PIC24FJ256GA110 FAMILY

PIC24FJ256GA110 Family Silicon Errata and Data Sheet Clarification

The PIC24FJ256GA110 family devices that you have received conform functionally to the current Device Data Sheet (DS39905E), except for the anomalies described in this document.

FIGURE 2-3 FREQUENCY vs. ESR PERFORMANCE FOR SUGGESTED VCAP

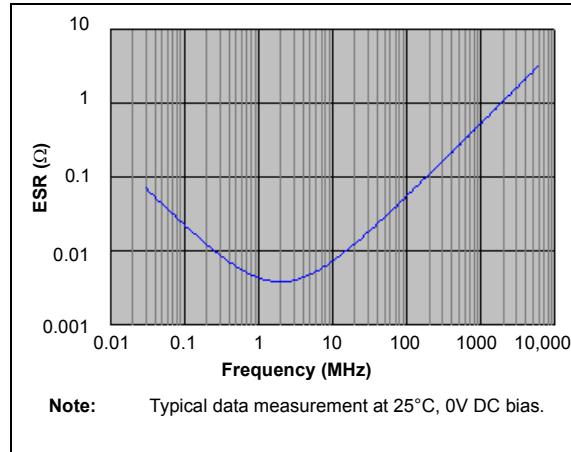
Section 2.4 Voltage Regulator Pins (ENVREG/ DISVREG and VCAP/VDDCORE) has been replaced with a new and more detailed section. The entire text follows:

When the regulator is enabled, a low-ESR ($<5\Omega$) capacitor is required on the VCAP/VDDCORE pin to stabilize the voltage regulator output voltage. The VCAP/VDDCORE pin must not be connected to VDD and must use a capacitor of $10\ \mu F$ connected to ground. The type can be ceramic or tantalum. Suitable examples of capacitors are shown in [Table 2-1](#). Capacitors with equivalent specifications can be used.

Designers may use [Figure 2-3](#) to evaluate ESR equivalence of candidate devices.

FIGURE 2-4

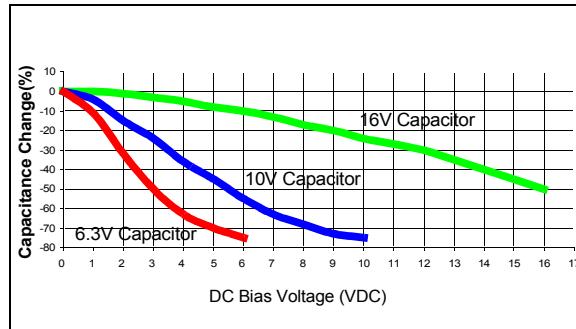
In addition to temperature tolerance, the effective capacitance of large value ceramic capacitors can vary substantially, based on the amount of DC voltage applied to the capacitor. This effect can be very significant, but is often overlooked or is not always documented.

A typical DC bias voltage vs. capacitance graph for 16V, 10V and 6.3V rated capacitors is shown in [Figure 2-4](#).

When selecting a ceramic capacitor to be used with the internal voltage regulator, it is suggested to select a high-voltage rating, so that the operating voltage is a small percentage of the maximum rated capacitor voltage. For example, choose a ceramic capacitor rated at 16V for the 2.5V core voltage. Suggested capacitors are shown in [Table 2-1](#).
